2015-097

Briggs Street Subdivision: Three Units Apartments
5 Briggs Street
Level III Subdivision and Site Plan Review
2015-097
Briggs Street Property, Applicant

Submitted to: Portland Planning Board:
Public Hearing Date: July 28, 2015

TO: Shukria Wiar, Planner
FROM: David Senus, P.E.
DATE: July 6, 2015
RE: Briggs Street Apartments, Final Level III Site Plan Application

Figure 2: View of the Proposed Building from Briggs Street

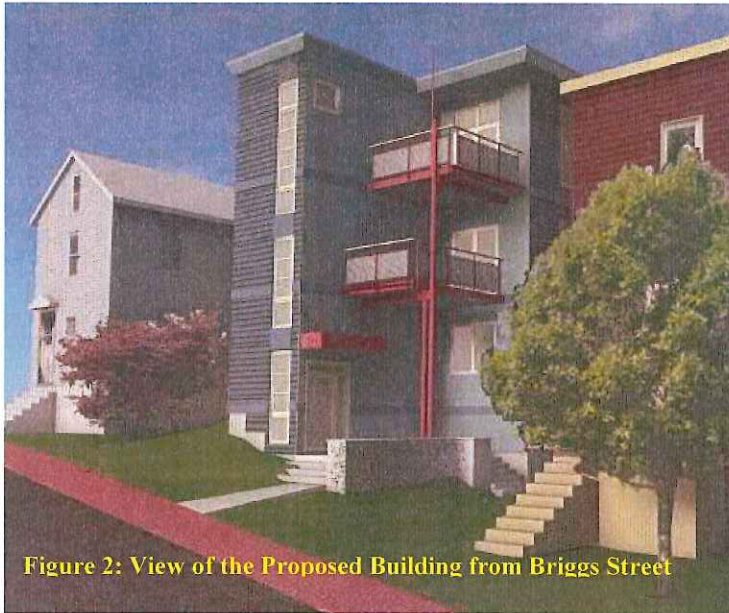
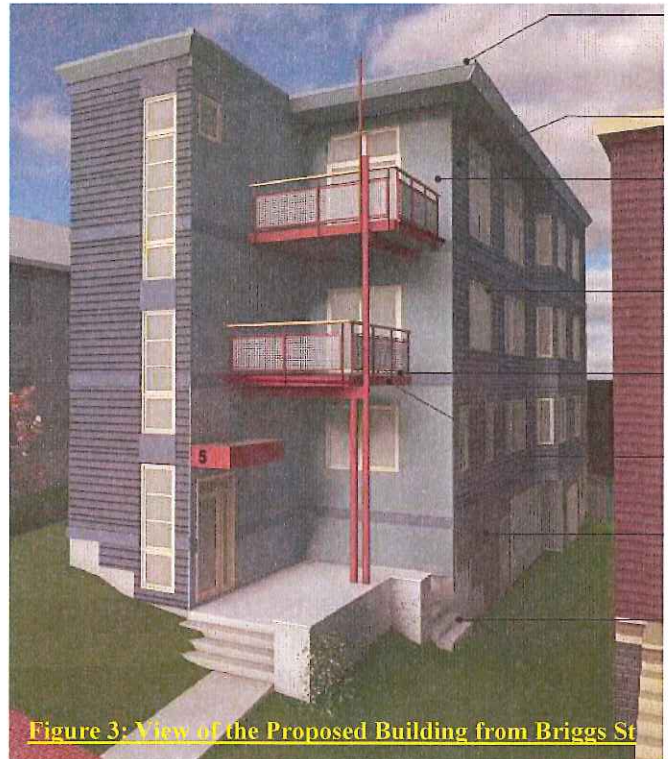
- *C-1 Entrances:* The main entry is emphasized with the canopy, stoop, and material/color articulation. **The access to the principal building entry was revised to provide direct access from the street to the building stoop. See additional drawings received 7.21.15**
- *C-2 Visual Privacy:* Visual privacy is adequately addressed; all ground floor windows appear to be higher than 48" above adjoining sidewalk grade.
- *C-3 Transition Spaces:* A front porch/stoop is provided. See comments below about revisions.

Standard 2 – Met – The front-most portion of the street-facing façade has a relationship to the street consistent with the surrounding building context. Preferably, the rest of that front façade would not be set back so far from the street. **The relationship of the main entry to the street was revised to provide a configuration that creates a more direct pedestrian path from the sidewalk to the door and that makes the front porch more comfortable and useable.**
